PENNSYLVANIA ELECTRIC COMPANY
THREE MILE ISLAND NUCLEAR STATION UNIT 1

Operating License No. DPR-50
Docket No. 50-289
Technical Specification Change Request No. 20

TECHNICAL SPECIFICATION CHANGE REQUEST NO. 20.a.

FIGURE 8
ORGANIZATION FOR IMPLEMENTATION OF
ENVIRONMENTAL TECHNICAL SPECIFICATIONS

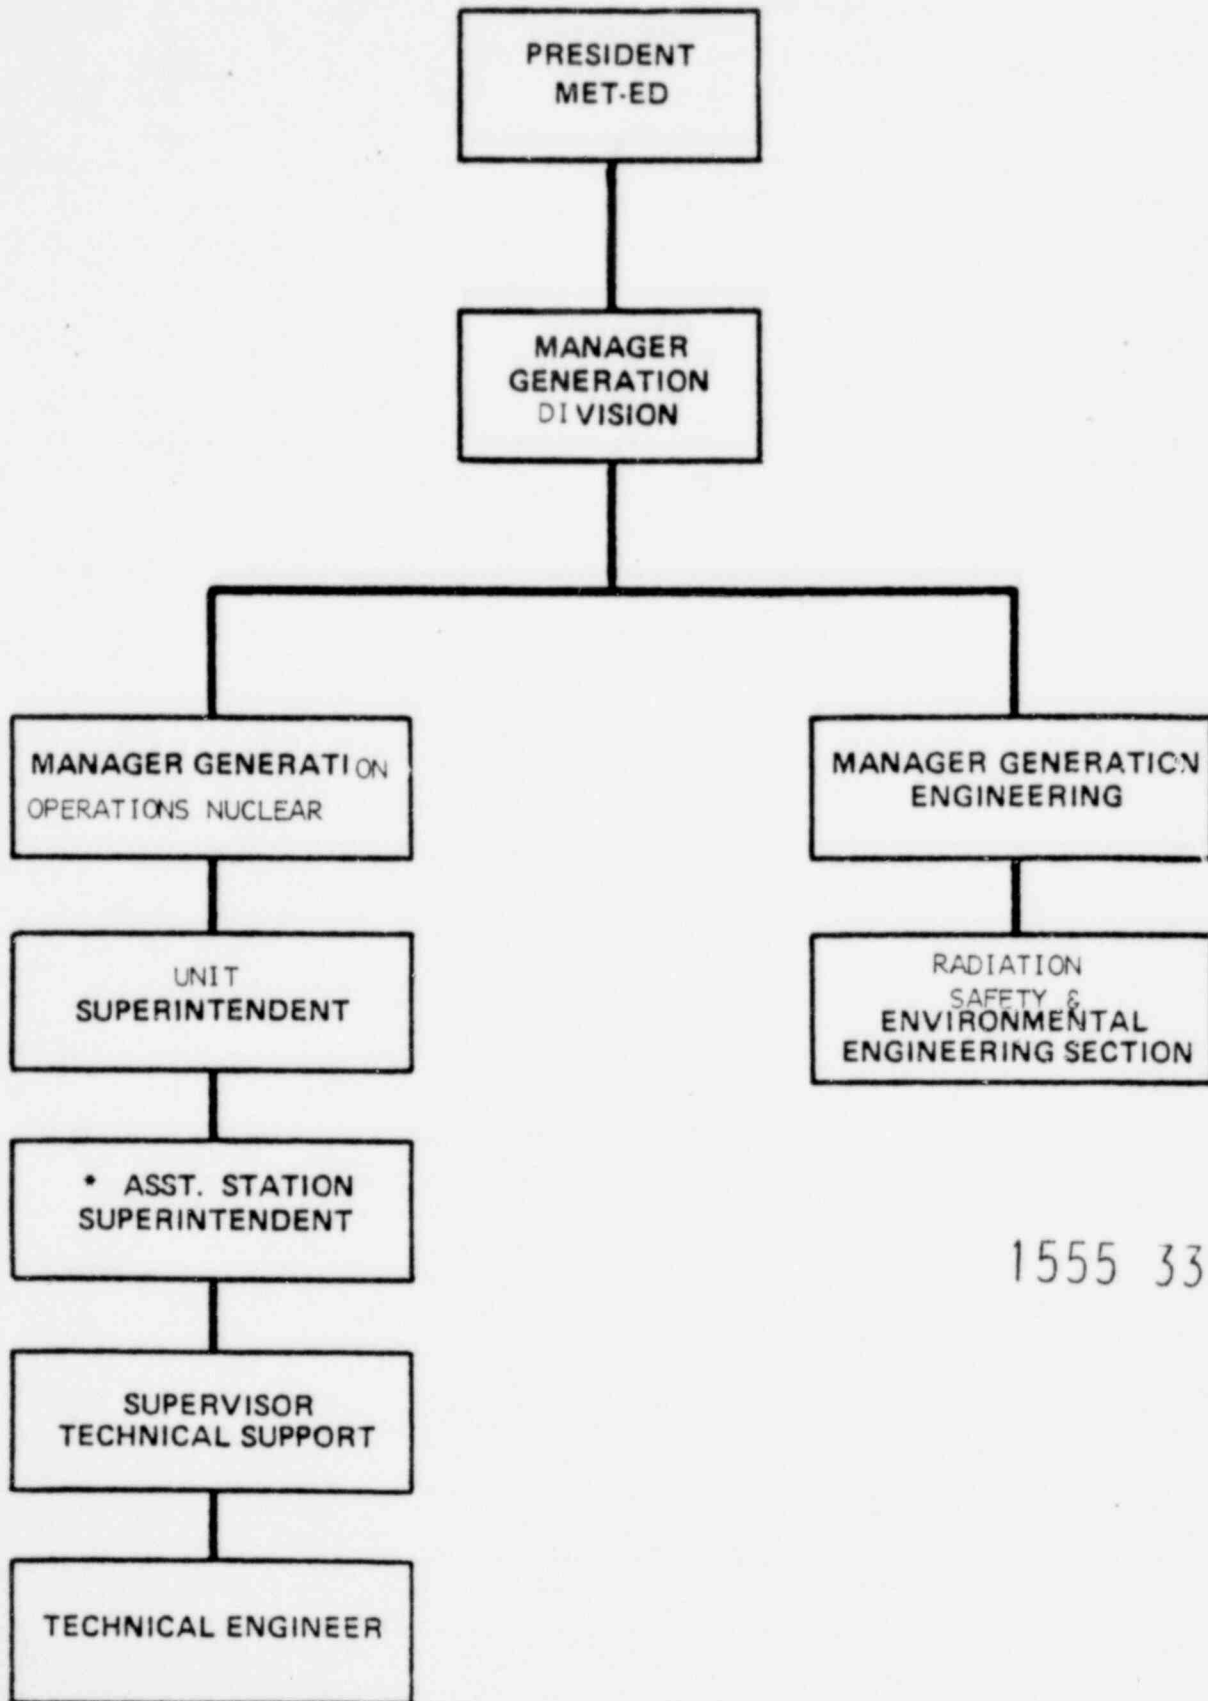
Page 59, Figure 8, Change "Manager-Generation Station" to "Manager-Generation Operations - Nuclear" and change "Radiological Protection" to "Radiation Safety", and change Station Superintendent to Unit Superintendent.

The reason for requesting the proposed change is to make all of the position titles referenced in the Technical Specifications consistent with current titles.
